Quality Control Check Report. Stage: Before Casting Slab (Apartments)

Company	GWE	Project	GWR	Phase	I
Prepared by	V. Ramesh Reddy	Sign	<i>[Signature]</i>	Date	31/3/10
Project Manager	Danjith Prakash	Sign	<i>[Signature]</i>	Date	31/3/10
Bungalow No Block	A (6, 11)	Slab No.	II	Other	
Receipt at HO date	6.3.10	Copy sent to site on	6.3.10	Sign	
Checked By MD on	19/3/10	MD Sign	<i>[Signature]</i>	For filling	<input checked="" type="checkbox"/> Yes <input type="checkbox"/> No

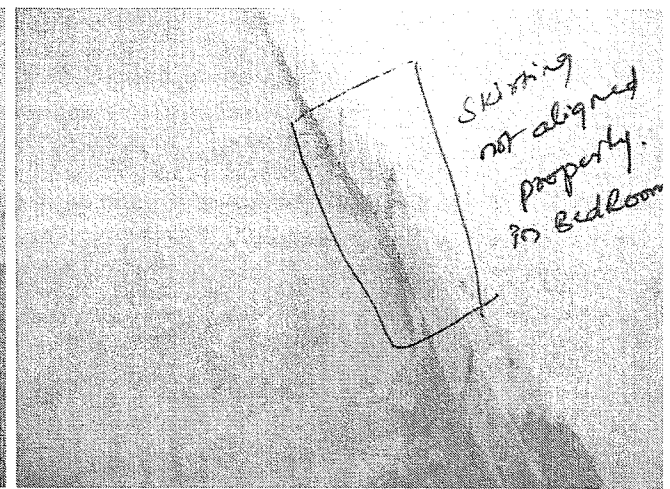
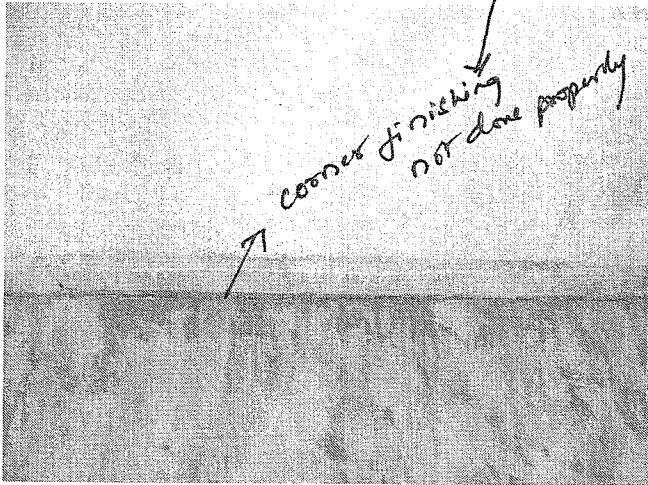
G.I. pipe not flushed inside the wall in utility

skimming not aligned properly in Bedroom

corner finishing not done properly

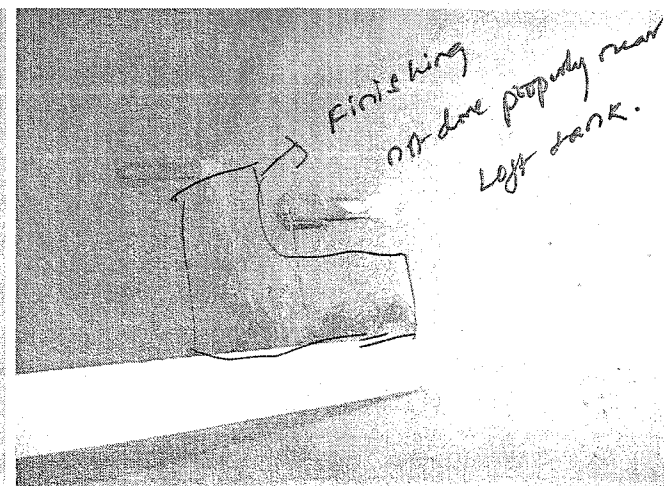
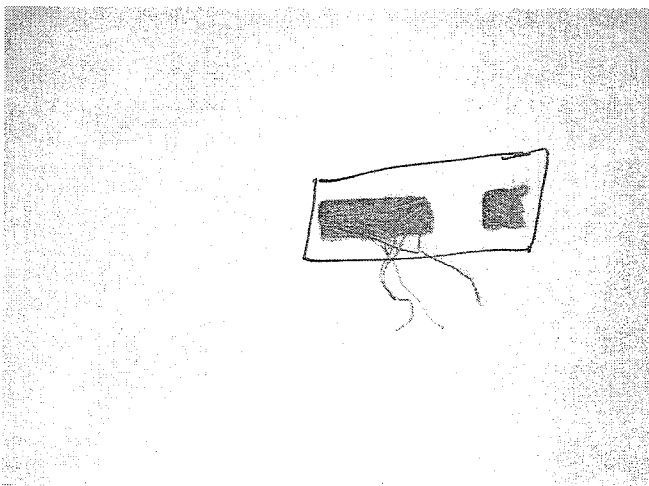
G.I. pipe not flushed inside the wall in utility.

Finishing not done properly near left tank.

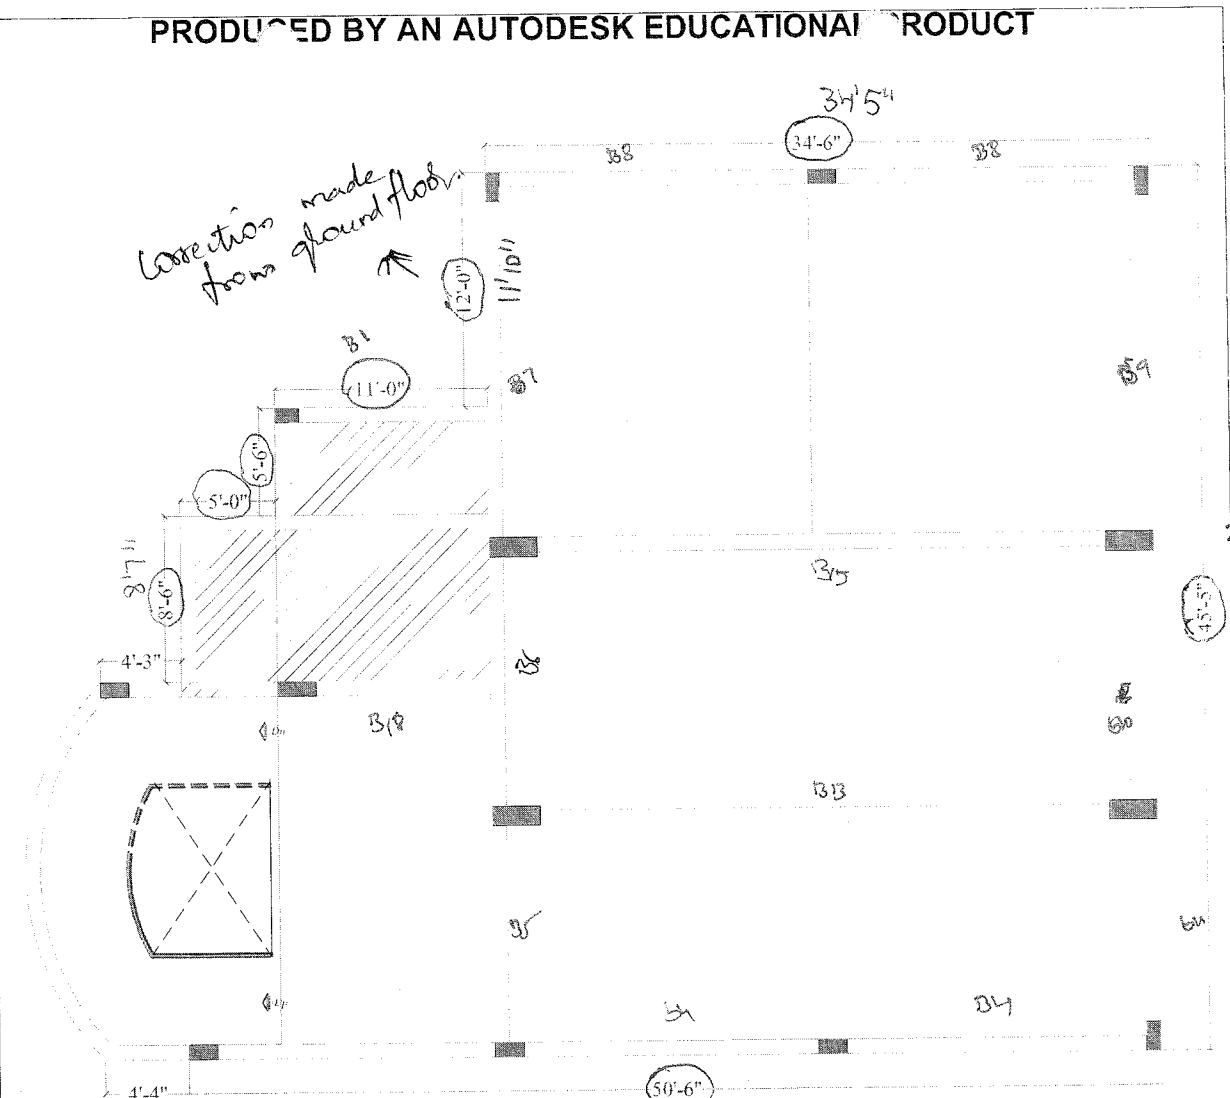
↓
Corrections are made from ground floor.

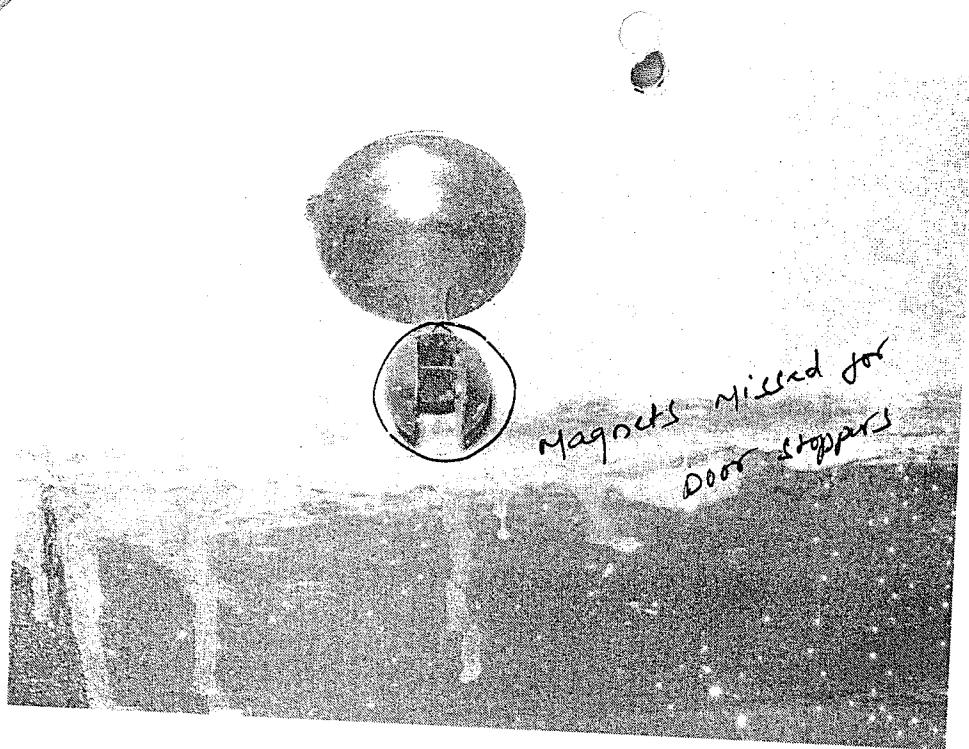
Magnets missed for
Door stoppers

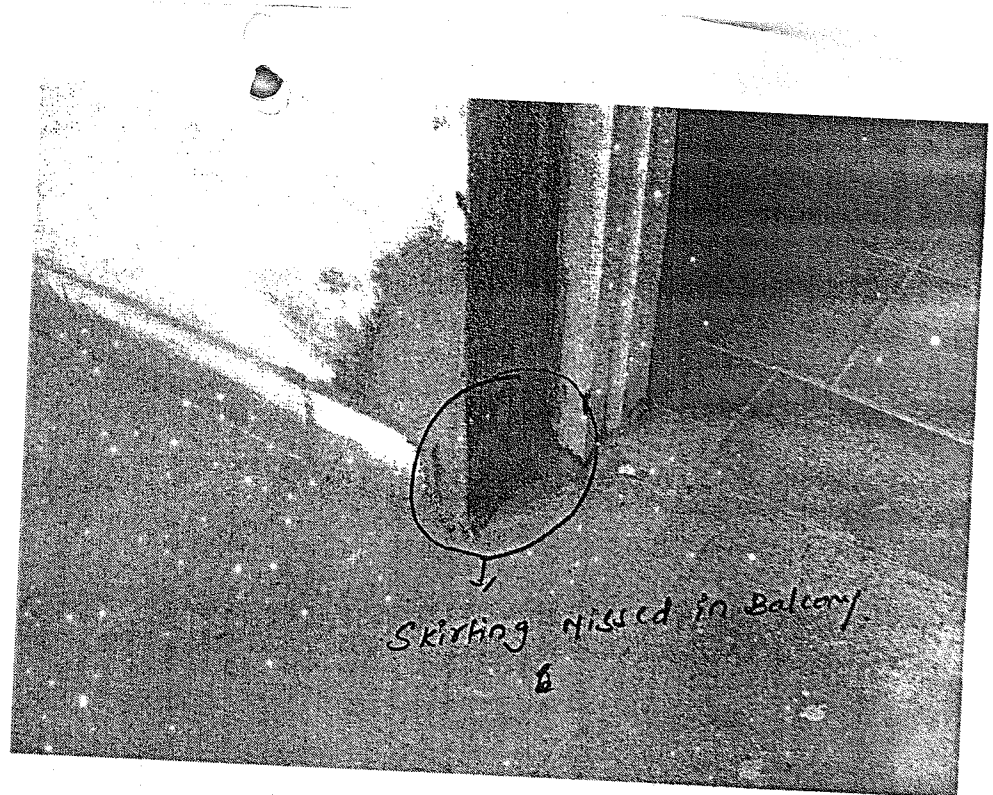
Skirting missed in balcony
B

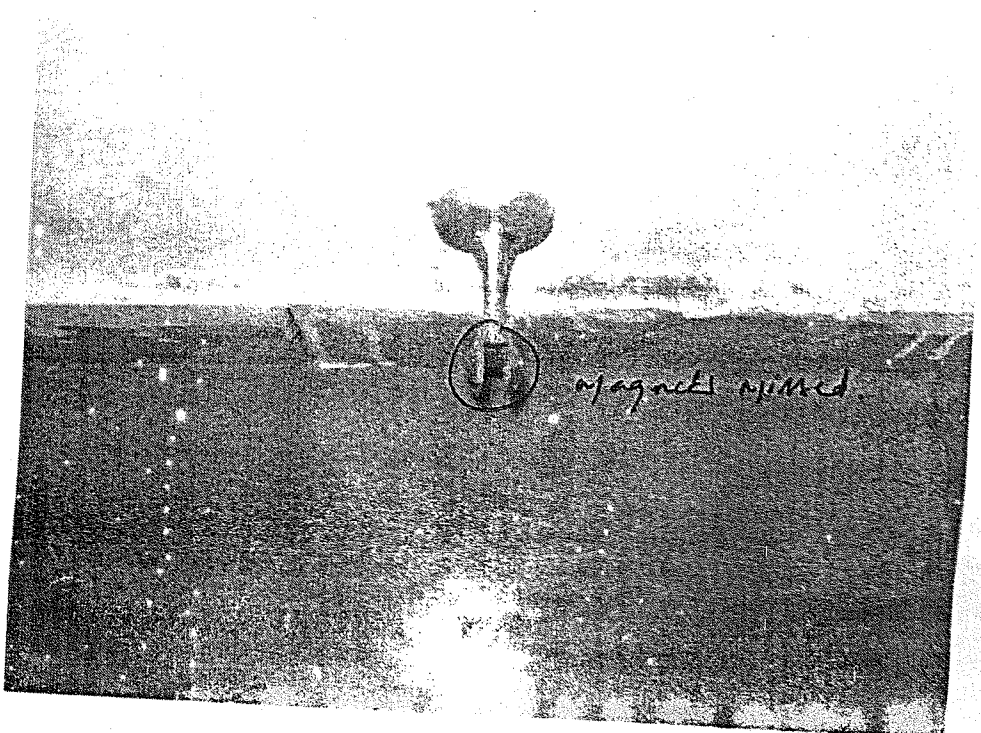
magnets missed
